September 27th, 2024

Addendum #1

Project Title: Capital Fund Program Improvements for **The Asbury Park Housing Authority**
New Common Area Flooring Work with Wall Base at
Lumley Homes A/B located at 1004 Comstock Street & 1025 Second Avenue
Comstock Court located at 1018 First Avenue
Dr. Robinson Towers located at 1000 ½ Third Avenue
Asbury Park, NJ 07712

A-100.00

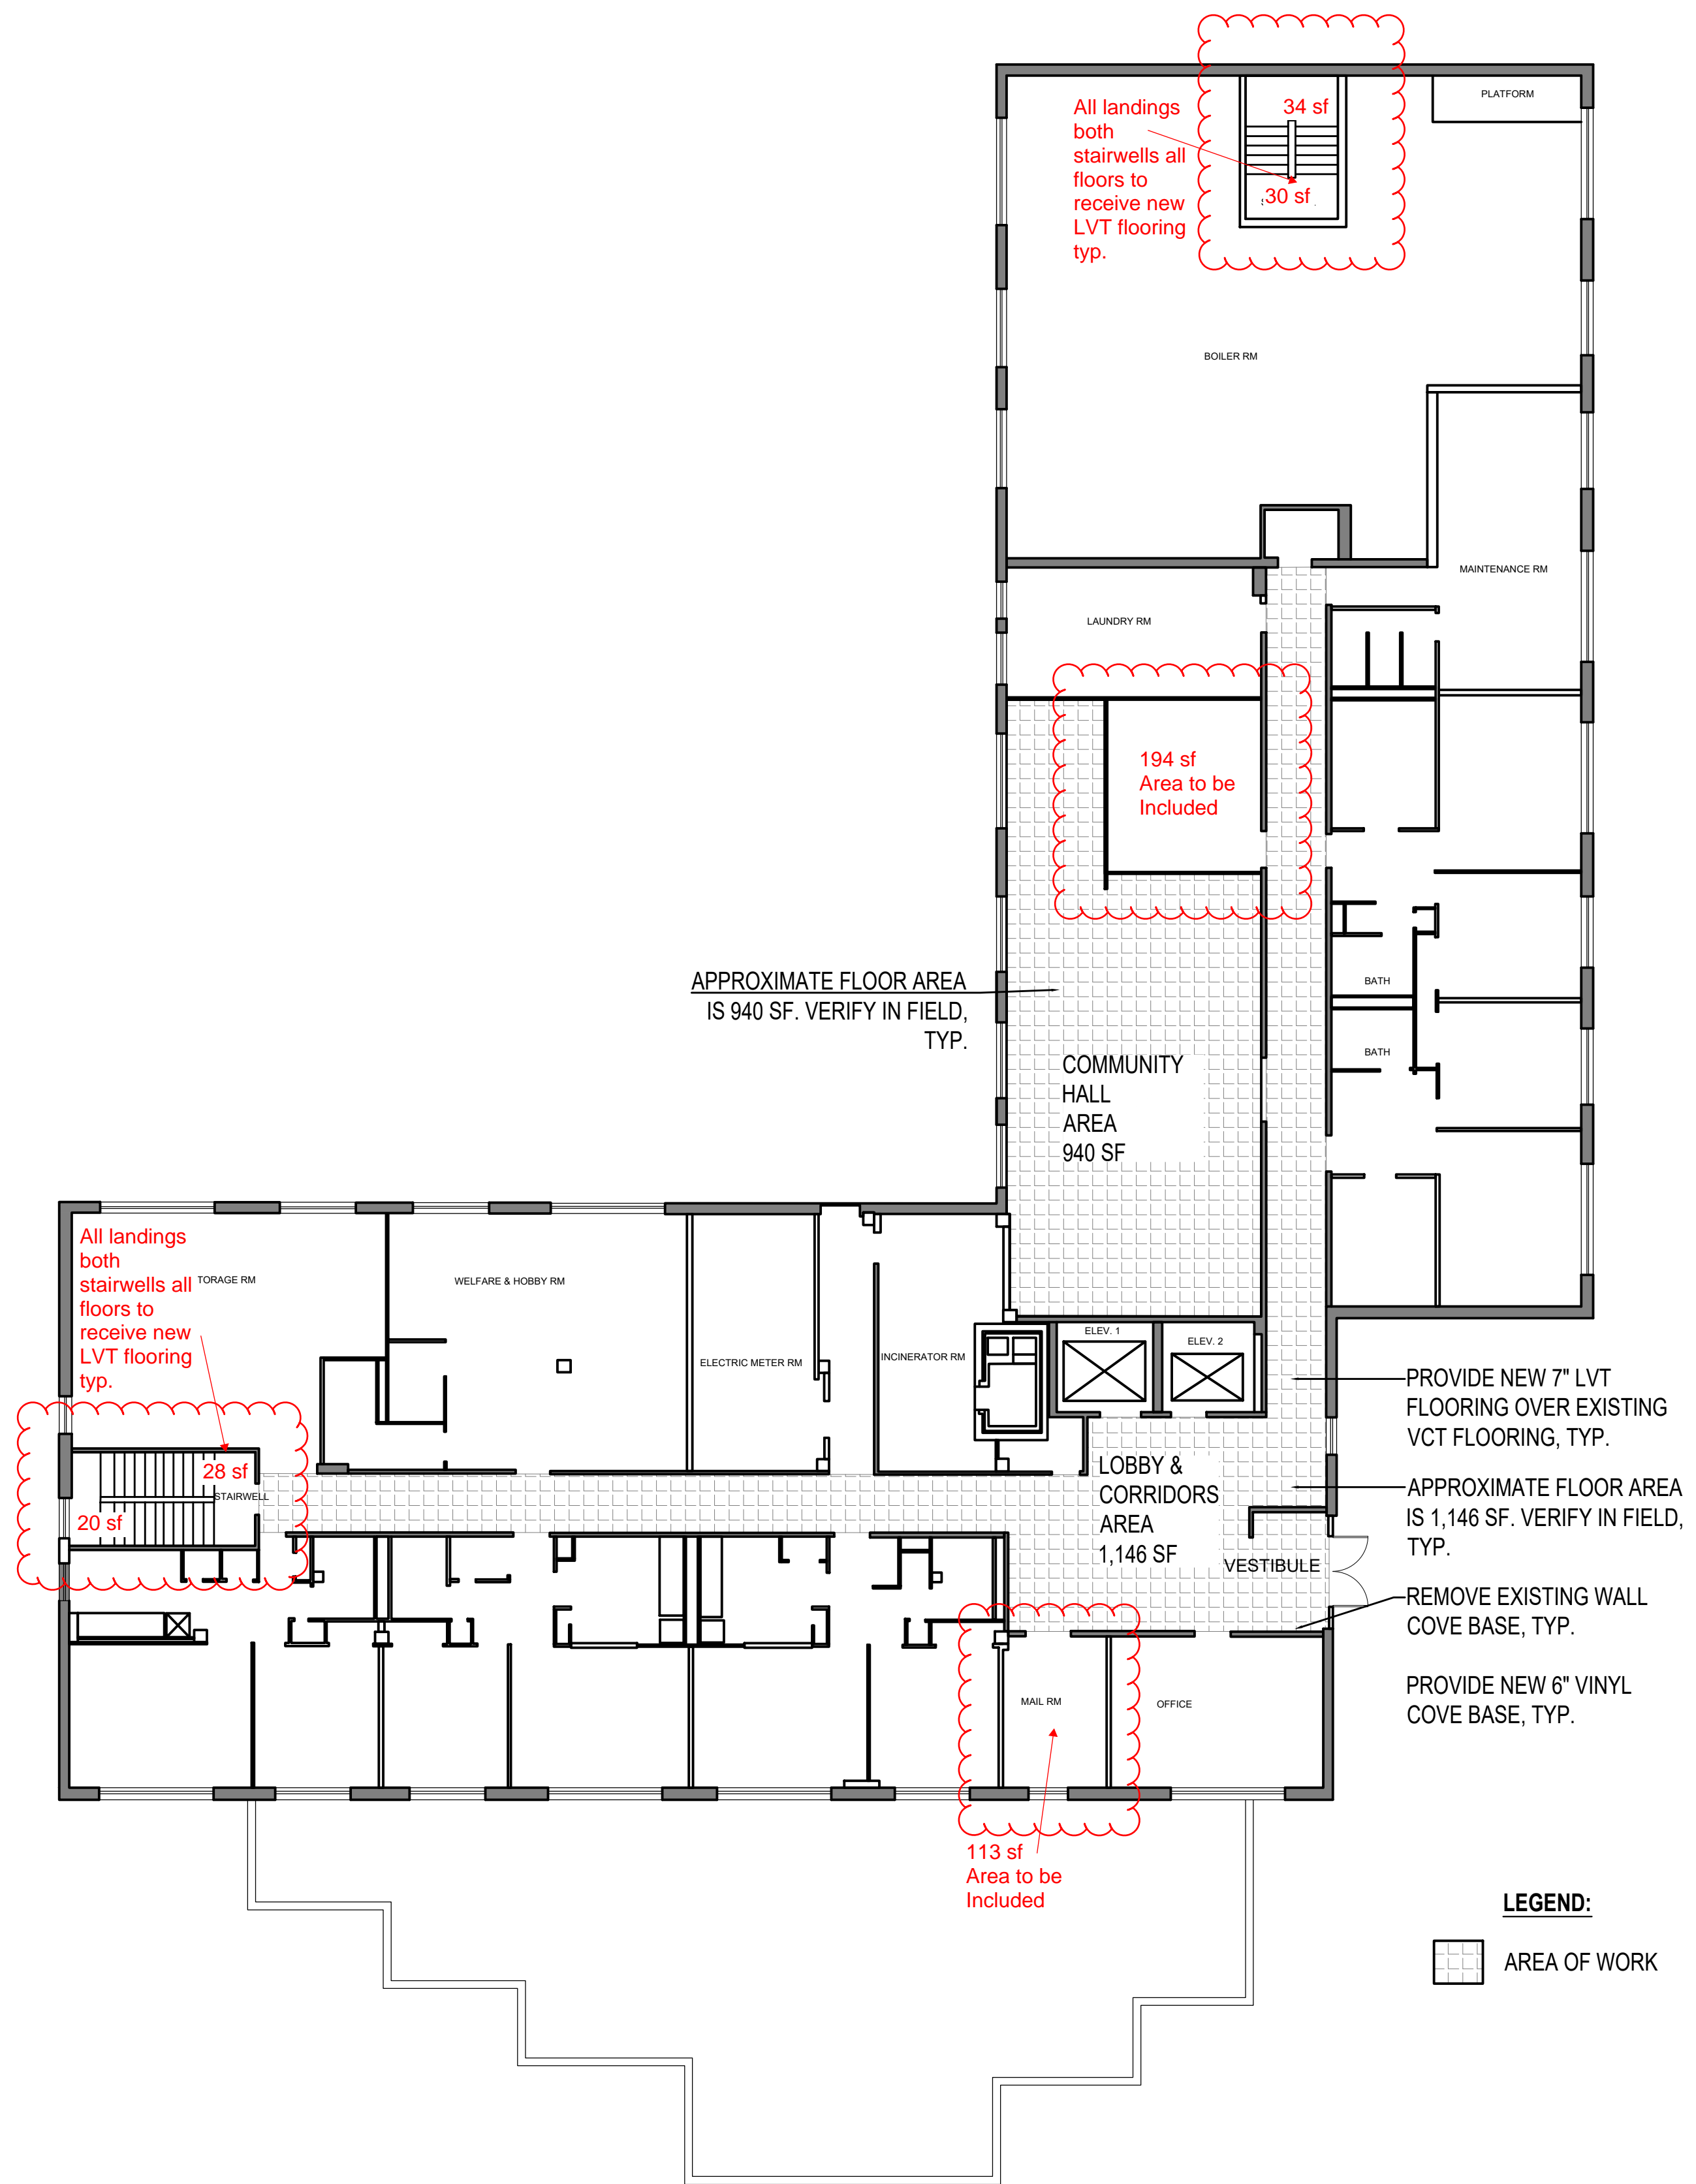
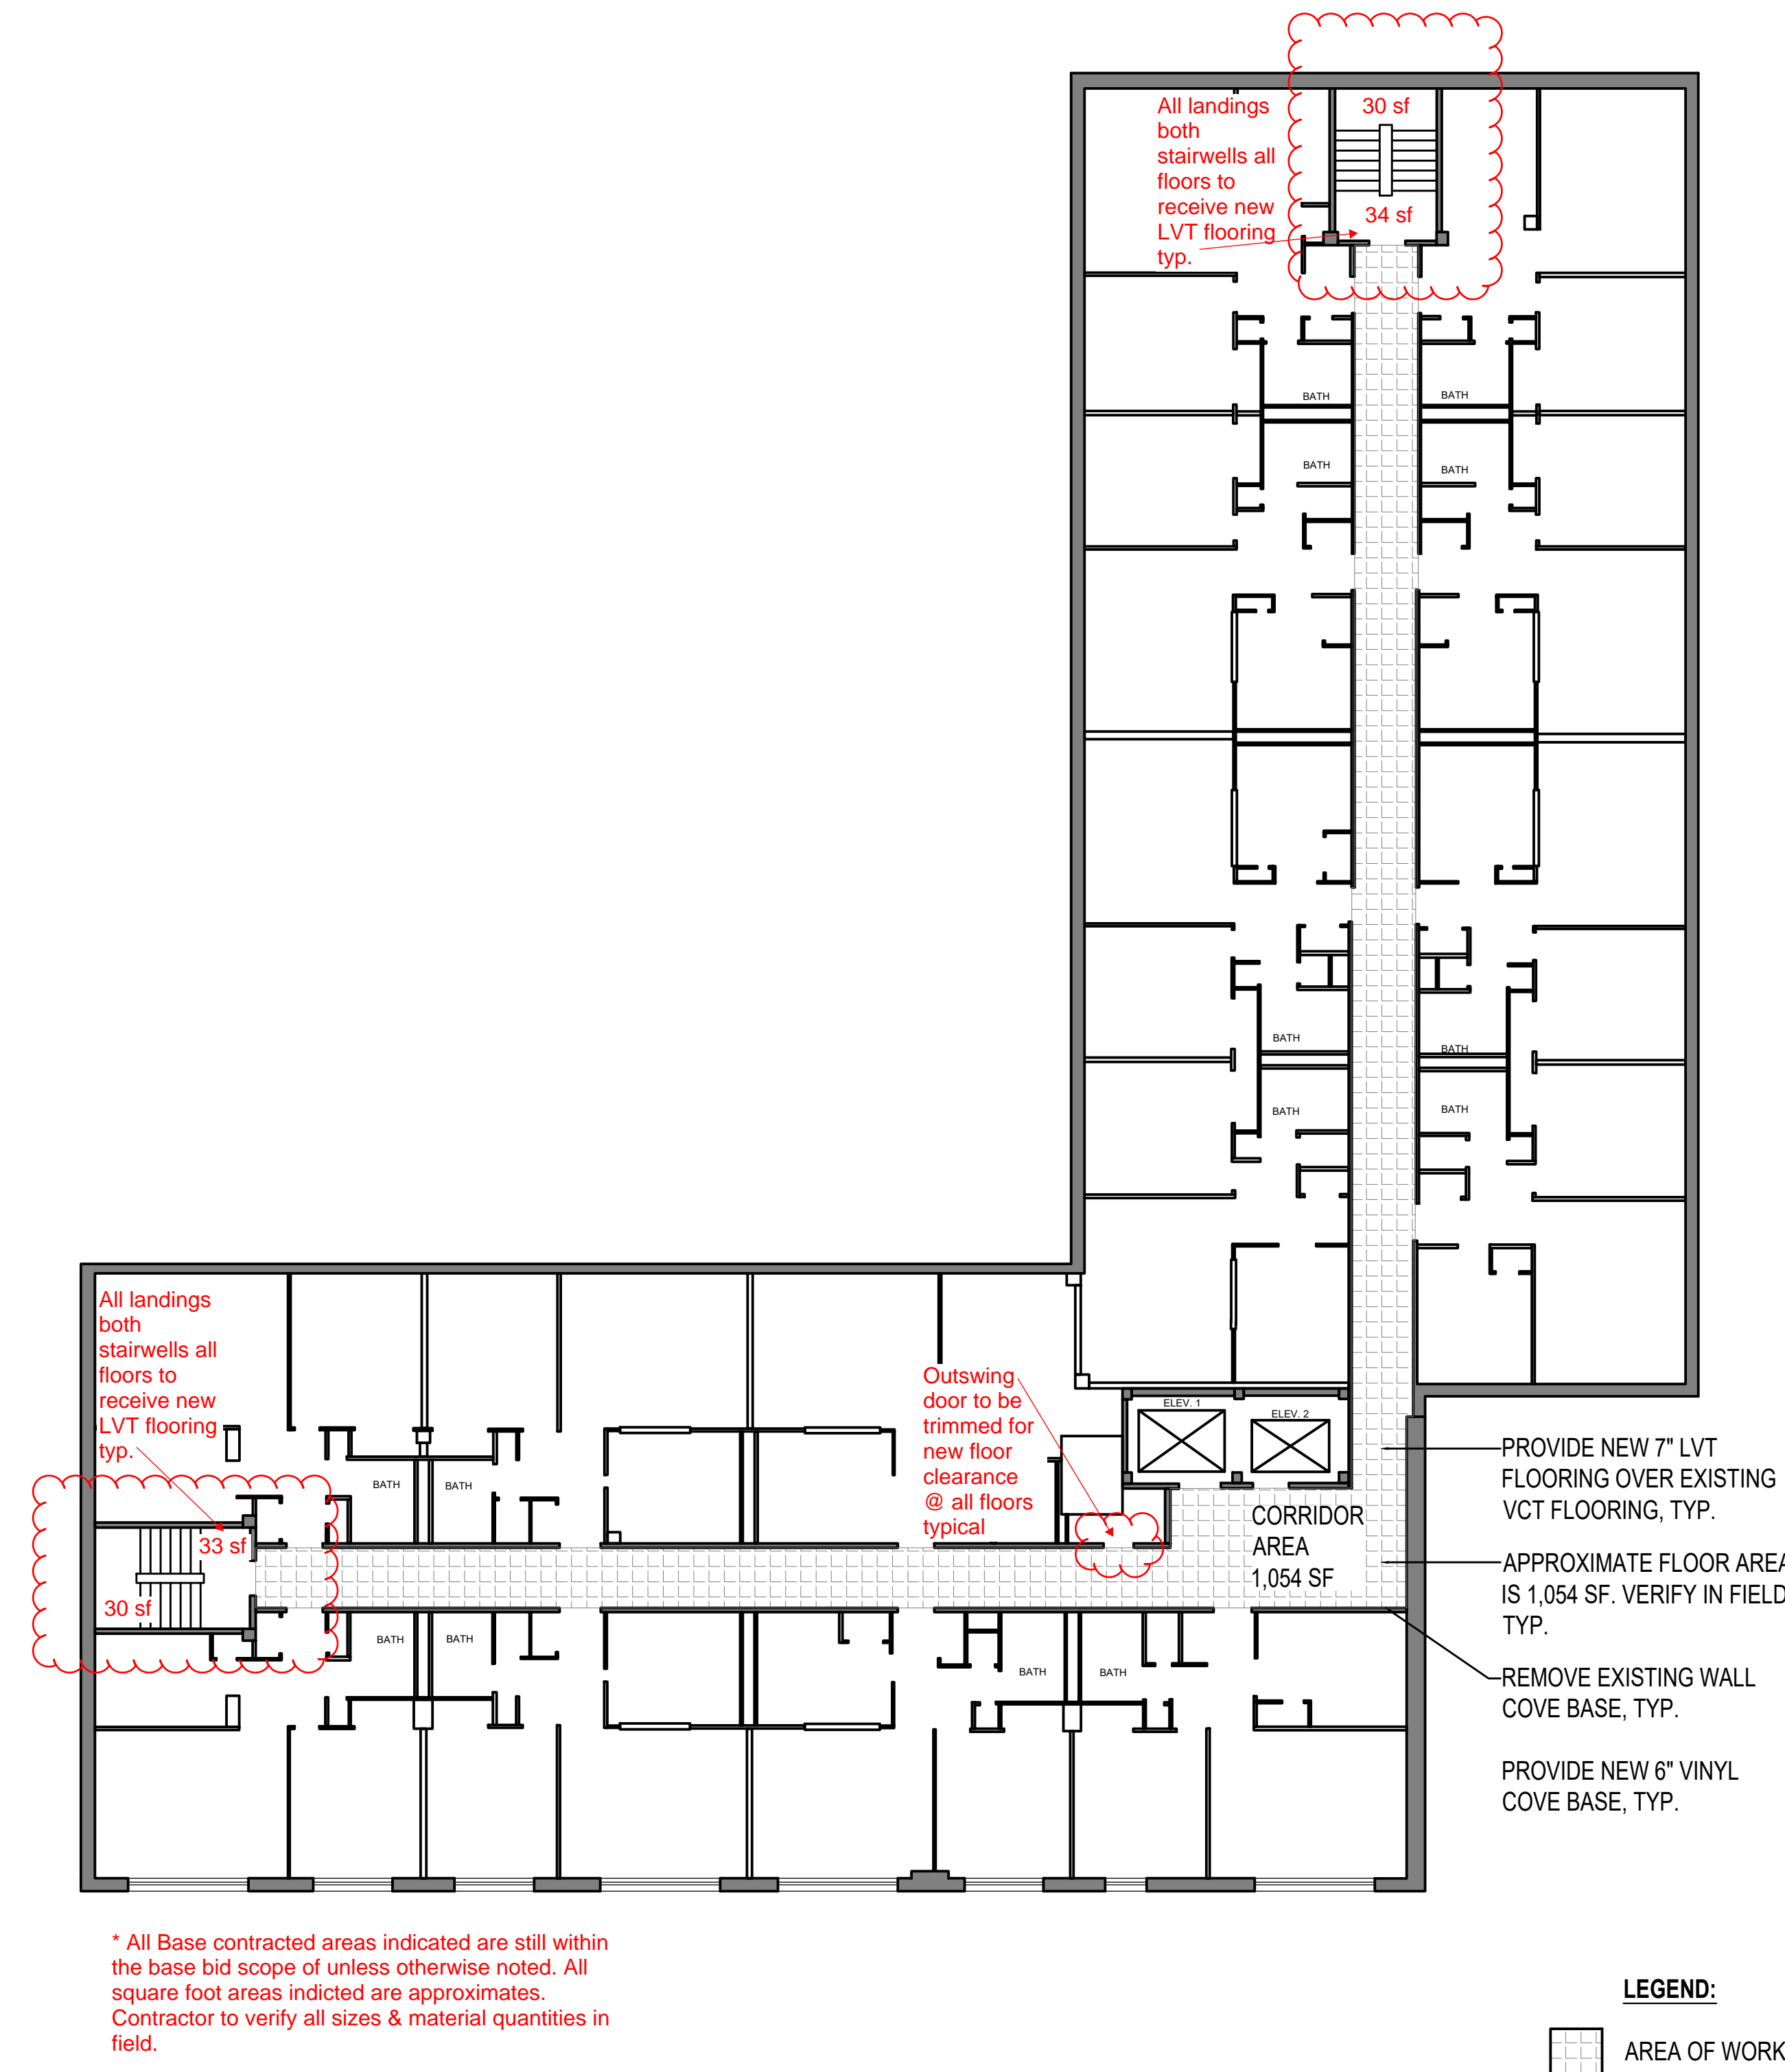
For Dr. Robinson Towers – Sheet A-100.00 Attached

2. Pre-Existing Mailroom as indicated within drawing to be included in the new flooring base scope of work.
3. All Stairwell landings (two stairs in total – mid & top/bottom) are to receive new flooring as per the base scope of work. There are 8 floors within this structure. Contractor required to provide reducers & trim pieces as needed to smooth transition of LVT.
4. At Floors 2 thru 8 there is an existing 3'-0" hollow metal storage closet door that required undercutting. It will be the flooring contractor's responsibility to undercut the pre-existing door. It is recommended not to remove this door off the hinges. If contractor decides to remove door off the hinges it will be their responsibility to re-install and maintain a fully operational door. Location is indicated on drawings.
